TOWN OF ARLINGTON

CONSERVATION COMMISSION

**RE: 1165R Mass Ave – Application for Comprehensive Permit
Third Set of Comments from Conservation Commission – Waiver Requests**

SHEET TITLE:
PROPOSED AURA EXHIBIT

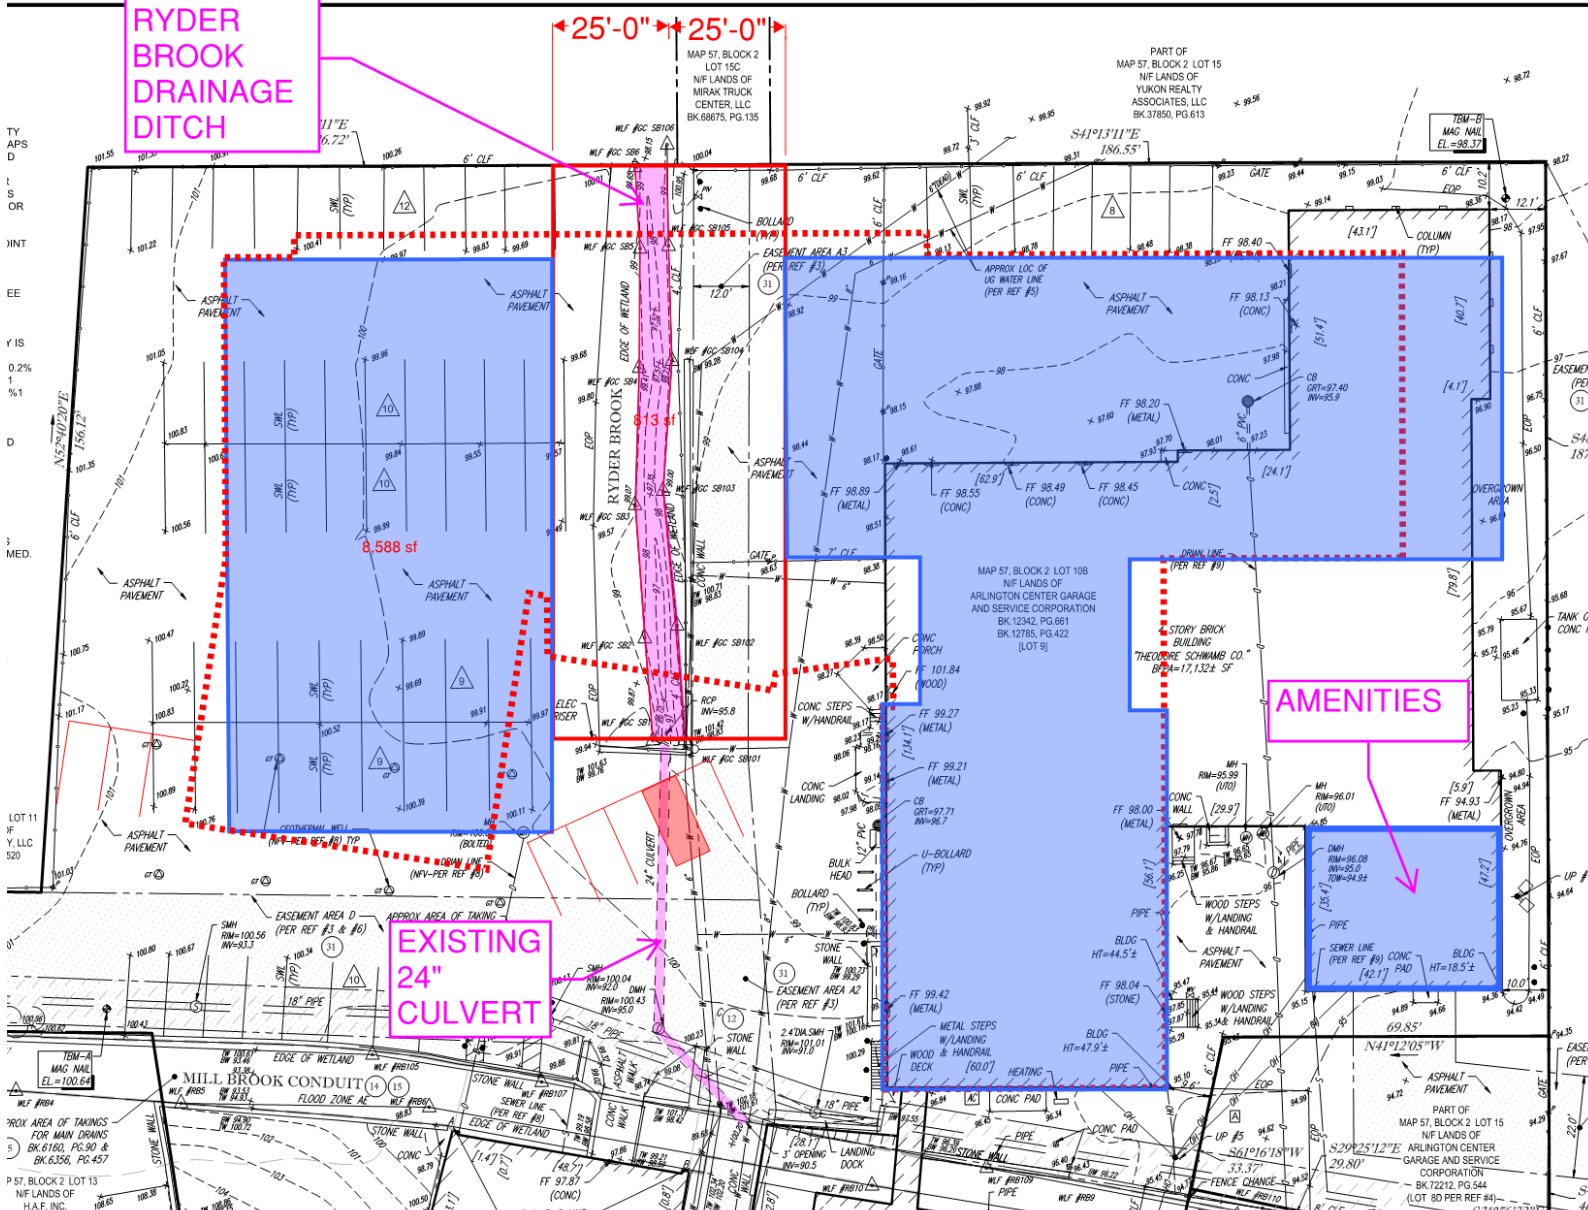
| Proposed Waivers | Comments on Waiver Request |
|--|--|
| <p>Regulations, Section 25D – 25’ No Disturbance in Adjacent Upland Resource Area (AURA) Performance Standards This Waiver request was withdrawn via Applicant’s Legal Counsel letter dated June 7, 2021.</p> | <p>ACC disagreed with this waiver request and agrees it should be withdrawn. <u>Justification:</u> ACC maintains that the project as proposed is in compliance with Section 25D because the plan proposes mitigation to increase the pervious area in the 0-25’ AURA by 1,505 square feet, which is considered an enhancement of the resource area, as allowed with local approval. As shown in Attachment A of this letter, Mary Winstanley O’Connor, the Applicant’s Legal Counsel, provides a letter stating that the project as proposed complies with Section 25D and the Applicant withdraws this waiver request. Proof of compliance with Section 25D is detailed in Attachment B, Proposed AURA Exhibit, prepared by Bohler Engineering.</p> <p>ACC Recommendation: no further action required.</p> |
